Access Compliance Report

Public Rights-of-Way

Intersection ID: 2457	Main Street: CAMBELLTON_DR	Cross Street: CLARKE_CREEK_PY	Location: SE
ADA ID: B9F9D555749E	Ramp Type: PerpDiag	Initial Pass/Fail: Fail	Overall Compliance: No
Severity Score: 33.75			
Codes/Mitigation Info/Possible Solution		Field Measurements/Component Compliance

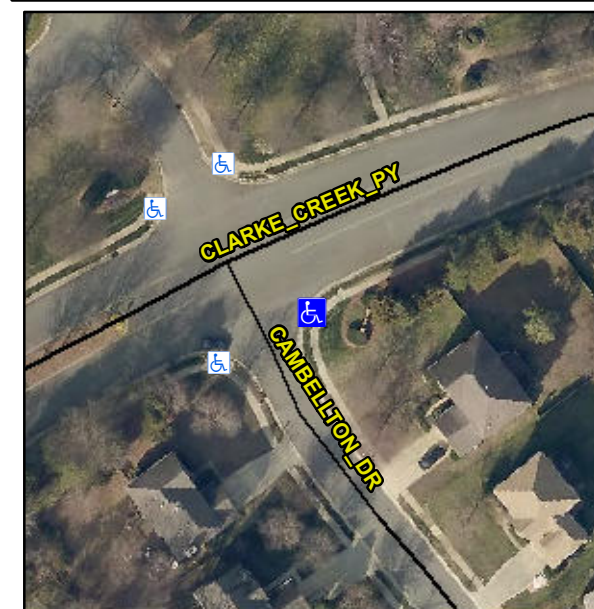
R304.5.1, R304.2.2, R304.5.3

Compliance	Description	Data	Compliance	Description	Data
N/A	Ramp Length (in)	49.0	No	Ramp Slope (%)	8.4
No	Ramp Width (in)	45.5	No	Ramp XSlope (%)	6.5
N/A	Flare Type LT	N/A	N/A	Flare Type RT	N/A
N/A	Flare Slope LT (%)	N/A	N/A	Flare Slope RT (%)	N/A
N/A	Flare Traversable LT?	N/A	N/A	Flare Traversable RT?	N/A
N/A	Landing Length (in)	N/A	N/A	DWS Provided?	N/A
N/A	Landing Width (in)	N/A	N/A	DWS Contrast?	N/A
N/A	Landing Slope (%)	N/A	N/A	DWS Length (in)	N/A
N/A	Landing X Slope (%)	N/A	N/A	DWS Full Width?	N/A
N/A	Landing Curb? (Y/N)	N/A	N/A	DWS Offset (in)	N/A
N/A	Shared Landing?	N/A			
N/A	Gutter Ponding?	N/A	N/A	Gutter Slope (%)	N/A
N/A	Gutter Lip Ht (in)	N/A	N/A	Gutter X Slope (%)	N/A
N/A	Painted X Walk1?	No	N/A	Painted X Walk2?	No
	X Walk 1 Direction	To N		X Walk 2 Direction	To W
N/A	X Walk 1 Width (in)	N/A	N/A	X Walk 2 Width (in)	N/A
	X Walk 1 Slope (%)	0.7		X Walk 2 Slope (%)	6.5
	X Walk 1 X Slope (%)	6.9		X Walk 2 X Slope (%)	0.4

N/A	Ramp inside XWalk1?	N/A	N/A	Ramp inside XWalk2?	N/A
	Road Slope (%)	4.2	N/A	Clear Space?	N/A
	Road X Slope (%)	5.0	N/A	Clear Space to XWalk (in)	N/A
N/A	Any Obstructions?	N/A	N/A	Storm Grate/Utility Hazard?	N/A
	Obstruction Type			Storm Grate/Utility Type	
		N/A			N/A
			Yes	Surface Condition? (G/P)	Good

Remove & Replace Curb Ramp With Two New Directional Ramps or Equivalent.
